STATE OF COLORADO

Re: FW: CEMEX TIS - Final

I read through the study today. I'm going to start this email with a note of appreciation that your company seemingly acted with Integrity here with your declarations. There's a lot of gray area in traffic engineering that allows for studies to be nudged to certain outcomes. When I read through the Stantec disclaimer at the beginning (which was far and away the lengthiest and most legal I've ever read in my 18-year career), I felt apprehensive about what I was about to read, especially since some level of the data collection pre2023 hinged on your company truthfully disclosing your traffic volumes to Stantec. All in all though it seems like a fairly well put together study.

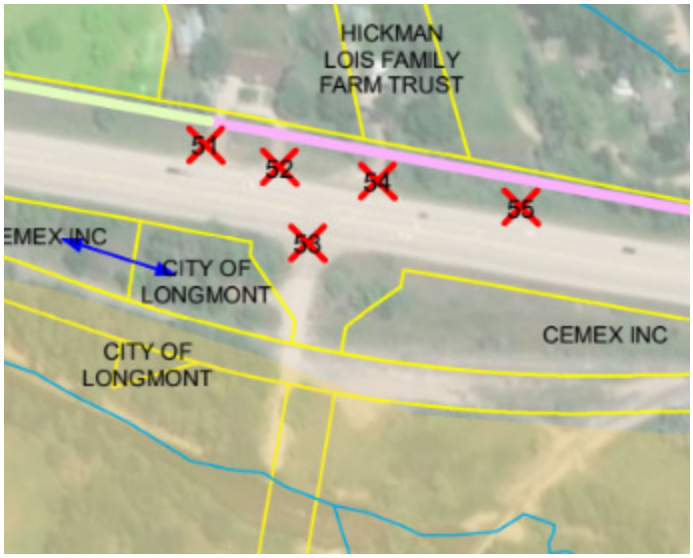
The study makes it clear though that we're well past the 20% threshold traffic increase to require a new permit under the Colorado Access Code:

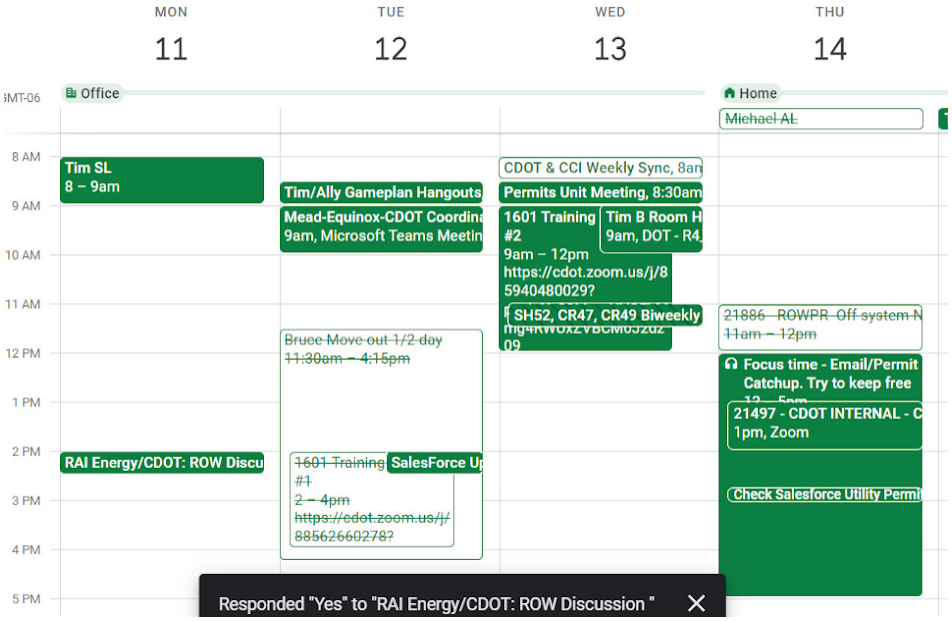
Since new permits are required from this office, part of the terms of the Highway 66 ACP & accompanying Intergovernmental Agreement, the associated access points need to come into conformance with the Highway 66 Access Control Plan:

Number 49 language necessitating the change to a 3/4 movement.

Access to the property will be obtained via Access 47.
29.376	49	South	Private Drive	Full Movement (Unsignalized)	**3/4 Movement**	Access will be restricted to less than full movement if a raised median is added to SH 66 as part of a roadway improvement project, if the property redevelops, or if operational and/or safety issues are identified through the completion of a traffic study.

Number 53 language necessitating the access closure.

29.466	53	South	51st St	Full Movement (Unsignalized)	**Access to be closed**	Access to properties south of SH 66 has been relocated to Access 49. This access will be formally closed and access will be obtained from existing Access 49.
						Access will be restricted to less than full movement if a raised median is

Vehicles will no longer be able to turn left out of access point 49 in these documents. for next steps we need to talk about what roadway construction needs to happen but before we do, I have a few more follow-up questions on the traffic study:
